PLAN

Improvement of Traffic Signals at ST. ANTOINE & FRANKLIN

UTILITY PLAN

66" STORM SEWER PLAN AND PROFILE

PLAN

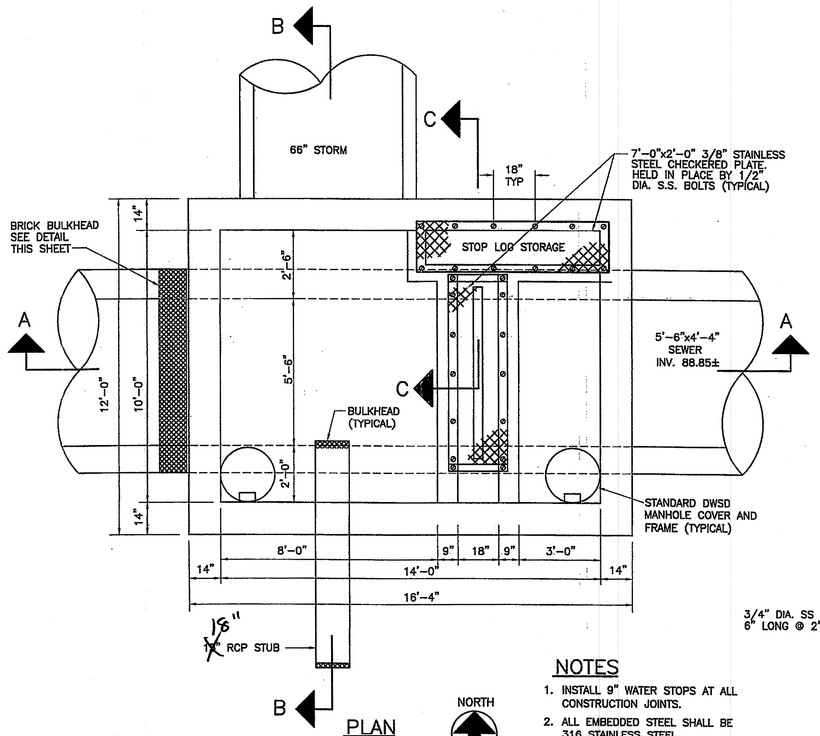
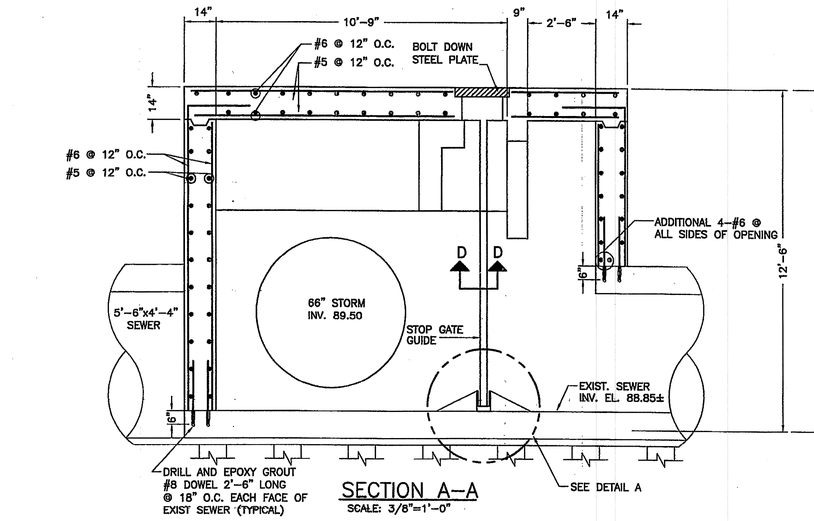
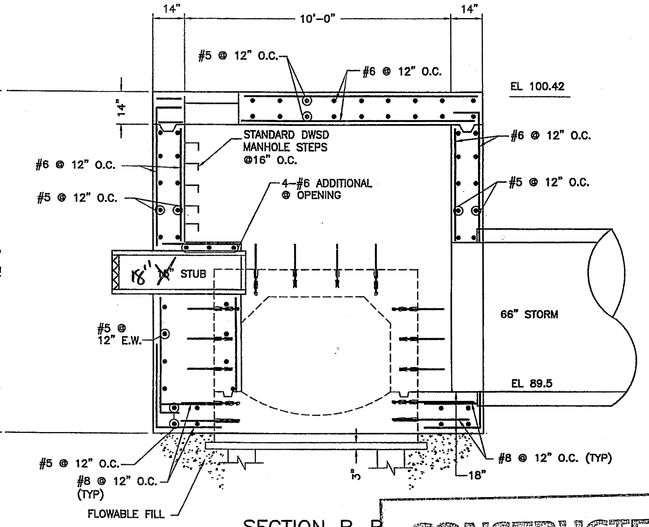
Date: 10-31-02 By: M. Kubien
Approved for: Revised MH 5A of drawing
Connection to: 2WS 5.10 revised on 10-014-02
Pipe Class:
☐ C-700 or ☐ C-76-CI III or ☐ Cast Iron
☐ Resident Inspector Deposit.....
☐ Sewer Assessment Due.....
Remarks.....
Remarks: ~~Construction is not to~~ begin in MH 5A until:

① Contractor shall dewater the sewer before making the saw cut. Contractor shall submit the dewatering plan to DWSD for review and approval prior to start of construction.

② Contractor shall maintain flow in the sewer during construction of manhole 5A. Bypass plan shall be submitted to DWSD for review and approval befor starting the construction of manhole 5A.

PLAN
SCALE: 3/8"=1'-0"
NORTH

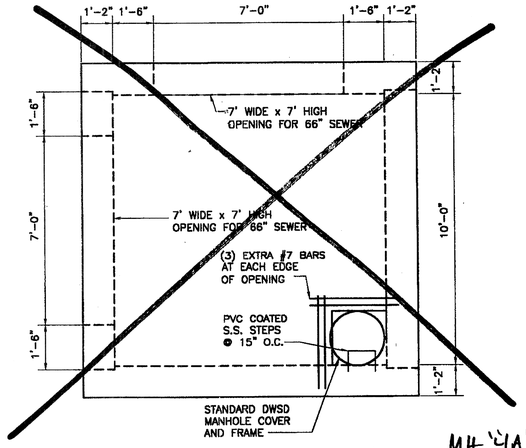
MH "4A" Changed to MH TEE and Bends.

MANHOLE (X)

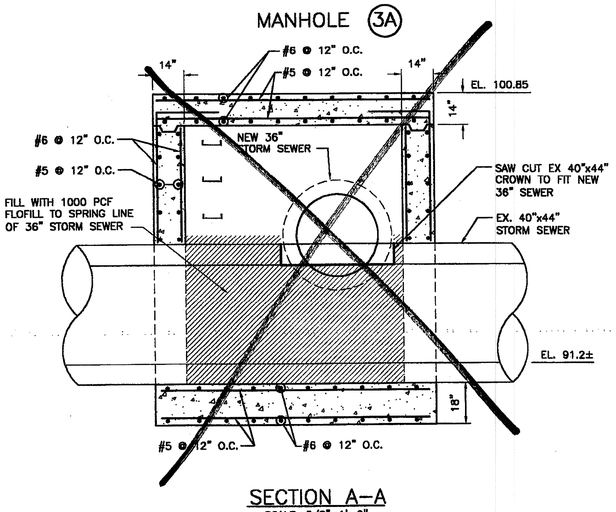
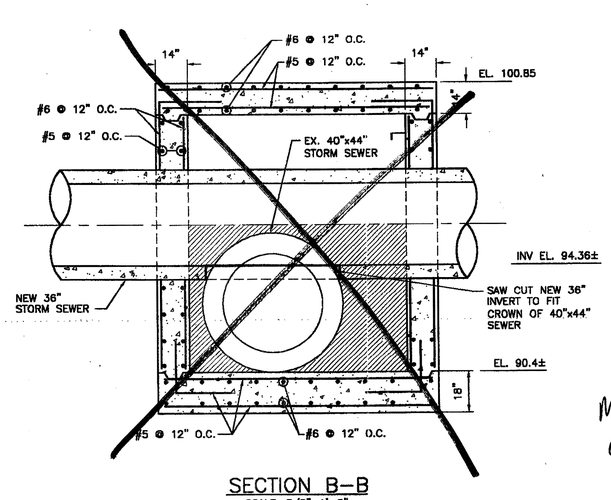
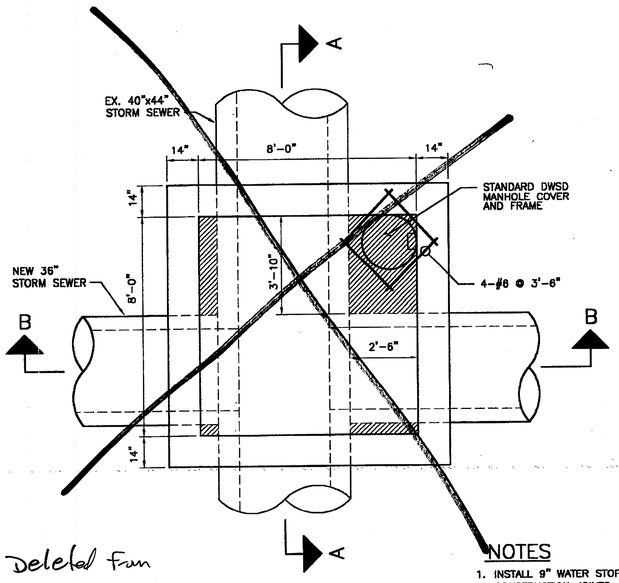
MH X Deleted from Contract.
